TANKLESS WATER HEATER Models GSWH-1/1M

INSTALLATION MANUAL ADDENDUM for after Market Installations

Fig. 1

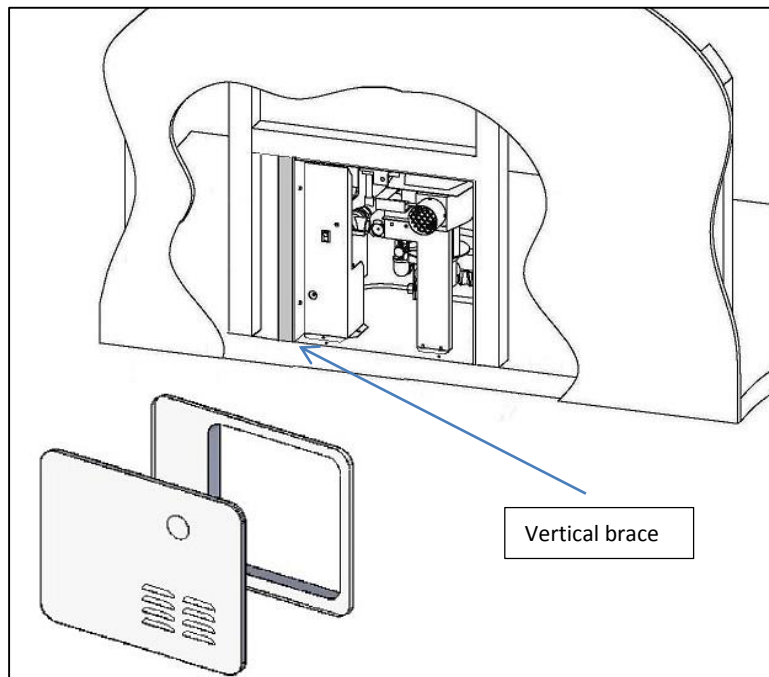
The existing cut out for a 6 gal Atwood water heater measures 16 1/4" (W) by 12 5/8" (H).

The cut out needed for your GSWH-1 is only 12 3/4" by 12 3/4" and its flange **MUST** be supported on all sides by a wooden frame so that it may be mounted rigidly with #8 3/4" flat head screws.

The flange will fit vertically into the existing opening, but a horizontal gap of 3 1/2" will be left between the new flange and the side of the opening.

A properly cut piece of 2" by 2" must be added as a vertical brace located at 12 3/4" from the right edge of the cut out. (See Fig. 1)

Fig.2

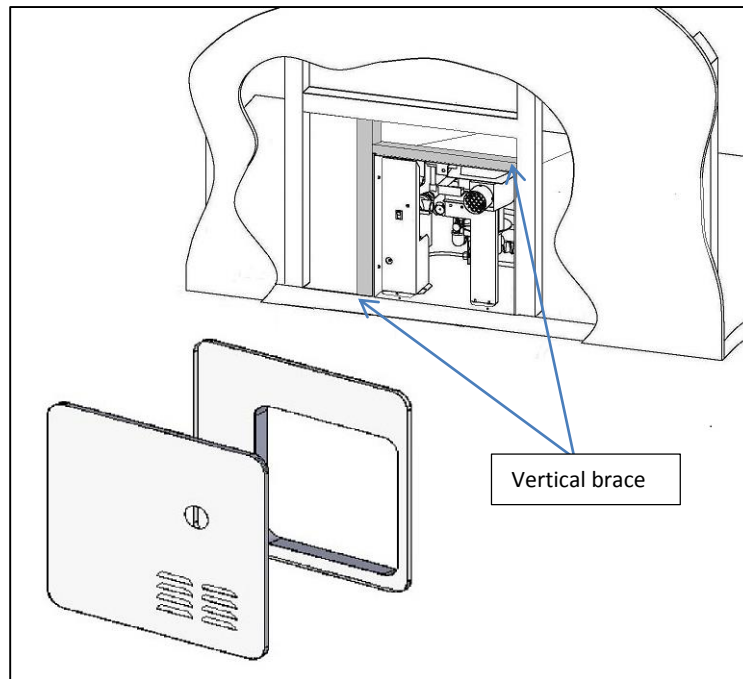
The existing cut out for a 10 gal Atwood water heater measures 16 ¼" by 15 ¾" and for a 10 gal Suburban unit measures 16 ¼" by 16 ¼" .

The cut out needed for your GSWH-1 is only 12 ¾" by 12 ¾" and its flange MUST be supported on all sides by a wooden frame so that it may be mounted rigidly with #8 ¾" flat head screws. A horizontal gap of 3 ½" and a vertical gap of 3" will be left between the new flange and the sides of the opening.

Two properly cut piece of 2" by 2" must be added as a vertical brace located at 12 ¾" from the right edge and 12 ¾" from the bottom edge of the cut out. (See Fig. 2)
